ONE 90 (PREVIOUSLY WATERS TECHNOLOGY PARK )  
PA 18-013 MODIFICATION SUBMITTAL :  
ISSUE DATE: 10-13-20

PA MODIFICATION - INTENT AND DESCRIPTION:  
To review and approve architectural building related design modifications made during plan check for code compliance and constructibility.

PA MODIFICATION COBALT- BLOCKS REVISIONS SUMMARY

PA MODIFICATION - INDIGO ROWS REVISIONS SUMMARY

ROOF LEVEL PLAN

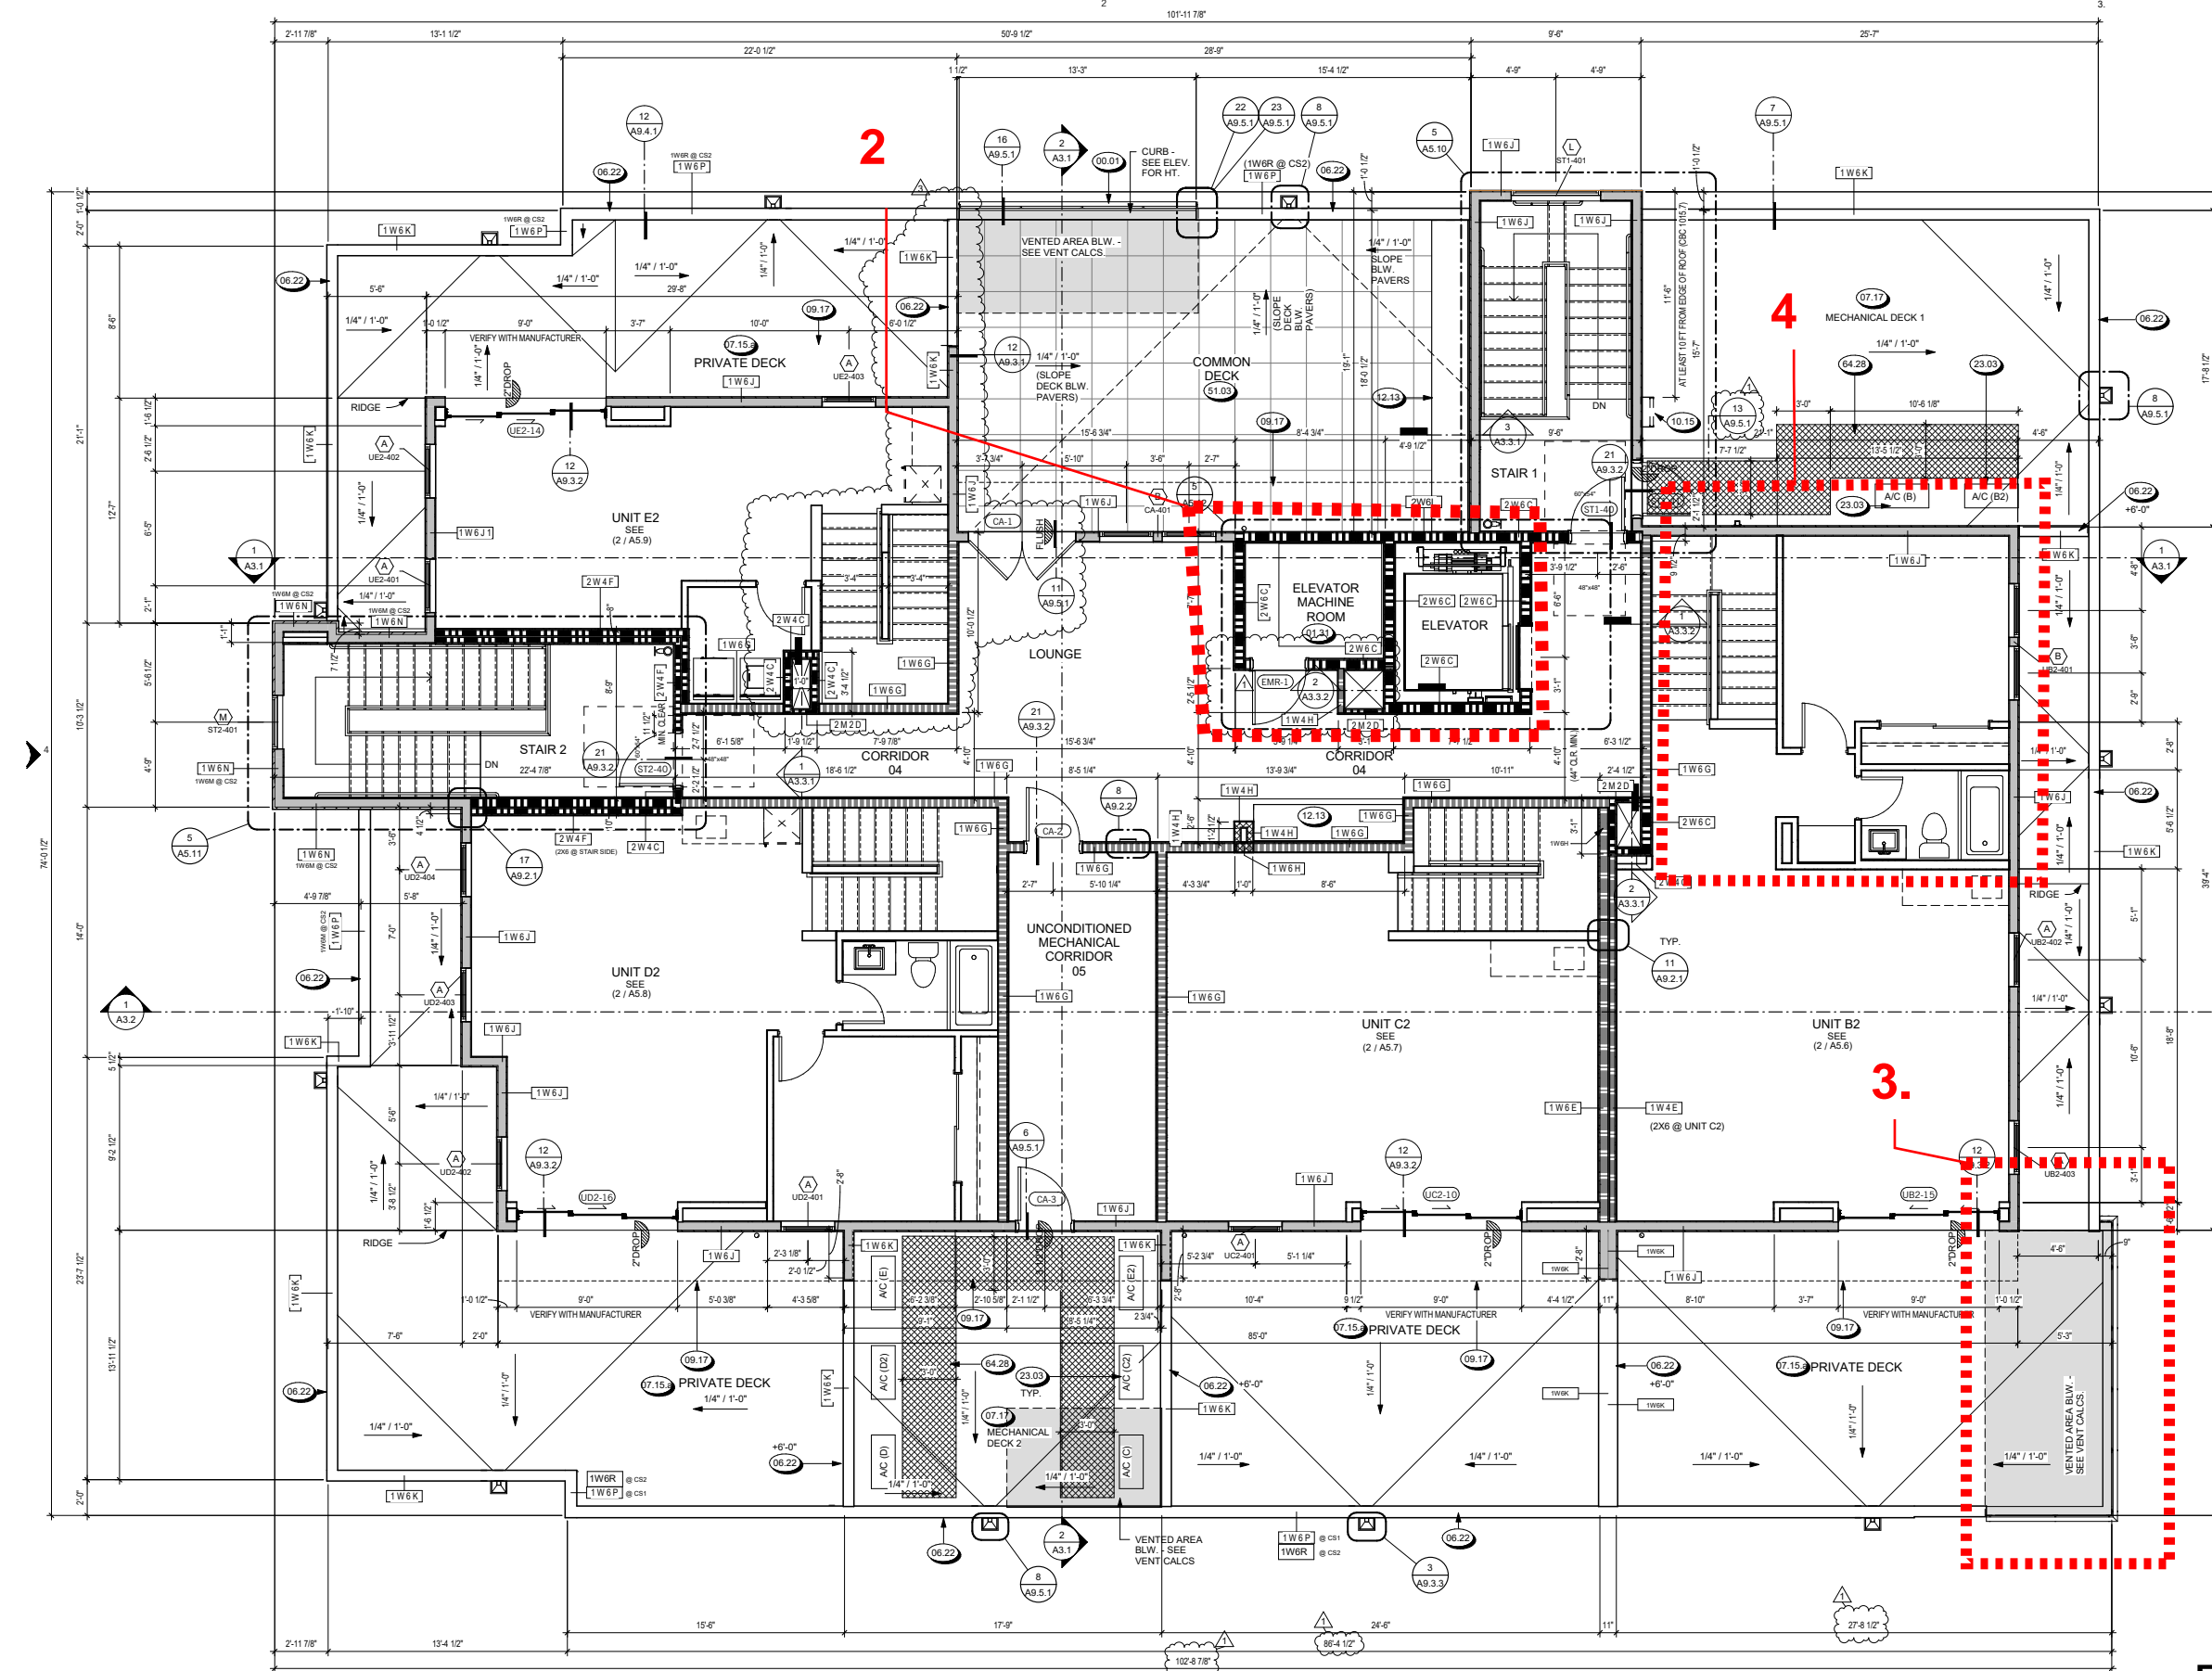
Providing alternative to PV system, installing 8'x 5' solar hot water systems on roof.

1. Reconfigured common hallway and exit stair to meet code compliance on all floors.
2. Extending both stairs to roof deck and added elevator mechanical room.
3. Reconfigured private roof deck by relocating the guard rails to the exterior corner for structural constructability
4. Extended living area for unit B2 to accommodate interior stairs. Created an accessible elevator vestibule

NORTH ELEVATION (CS1-SIDING)

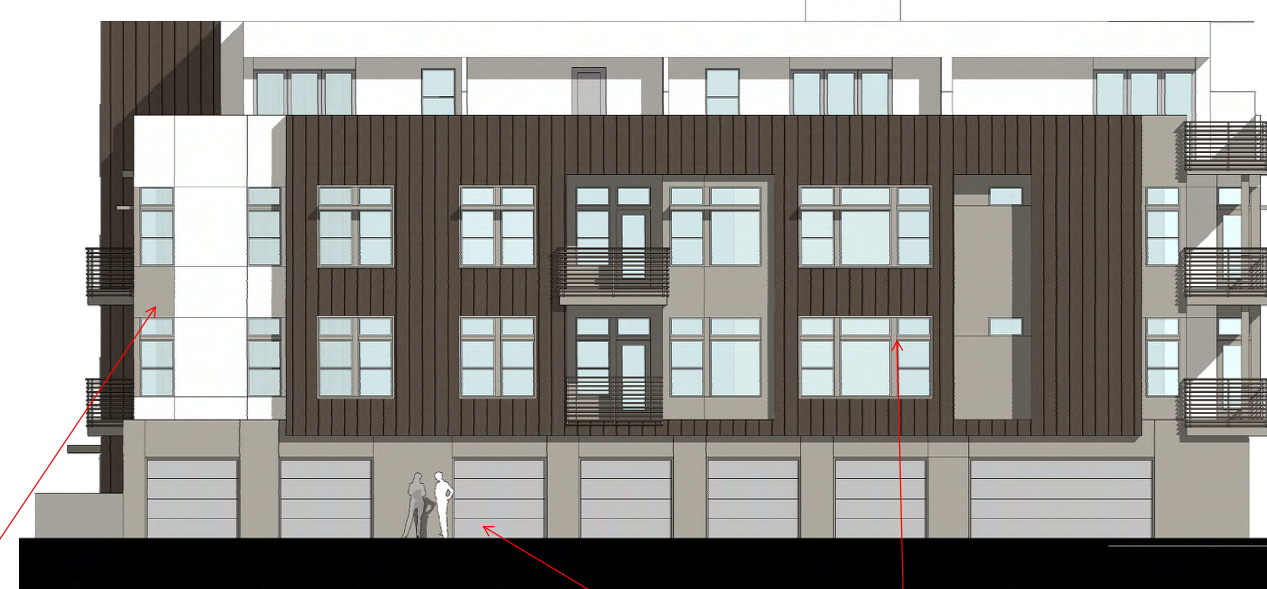
1. Minor massing configuration due to new exit stair and enclosing entry lobby exit stair
2. Garage door shifts due plan configuration and removing hallway
3. Removed Awnings/canopy between window and transoms due to conflicts with fire ladder locations.
4. Removed Bottom transom windows due to floor assembly thickness including acoustic measures required for code compliance which did not allow for adequate clearance between sill and bottom plate.
5. Revise windows and door color to white or tan
6. Previous application elevation heights do not match the sections and they are not code compliant. We cannot have 9'-1" to plate height at first floor from walk. It needs to be 9'-1" from top of slab to accommodate utility soffits and grading

SHEET  
A2.1

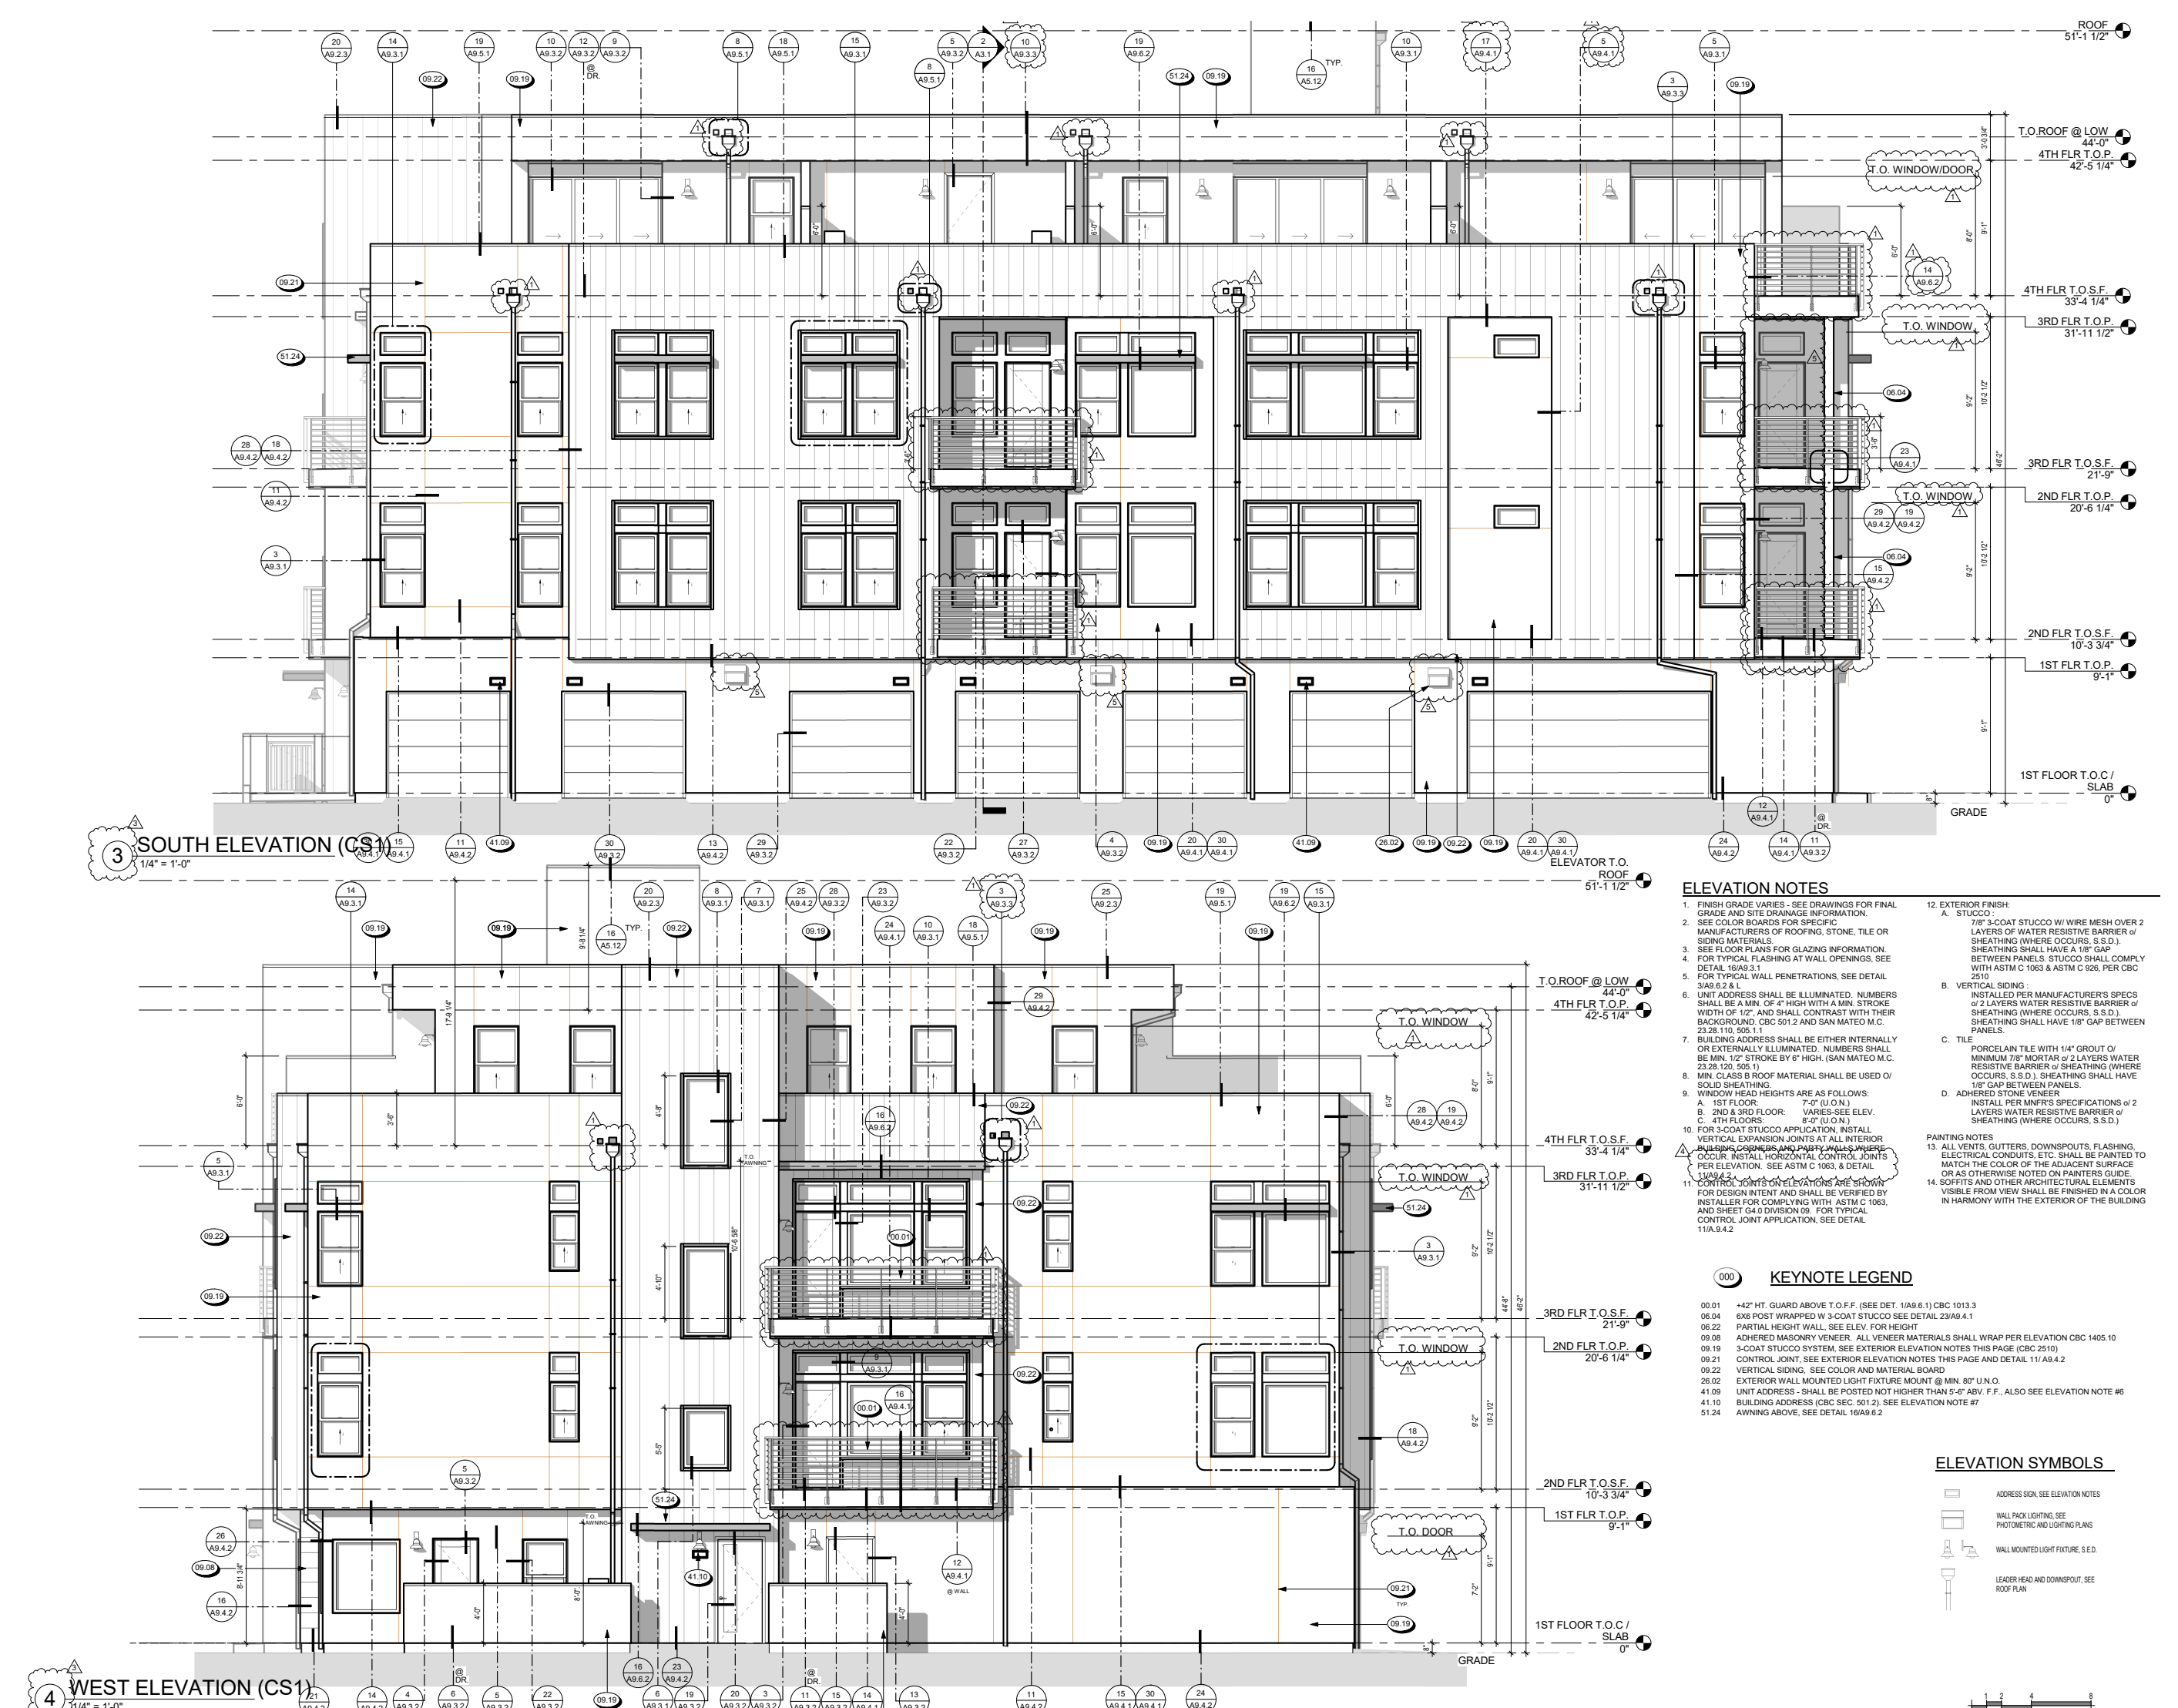
1. Minor massing configuration due to new exit stair and enclosing entry lobby exit stair
2. Garage door shifts due plan configuration and removing hallway
3. Removal of Awnings/canopy between window and transoms at second floor due to conflicts with fire ladder locations.
4. Removal of Bottom transom windows due to floor assembly thickness including acoustic measures required for code compliance.
5. Revise window color from silver to white or tan
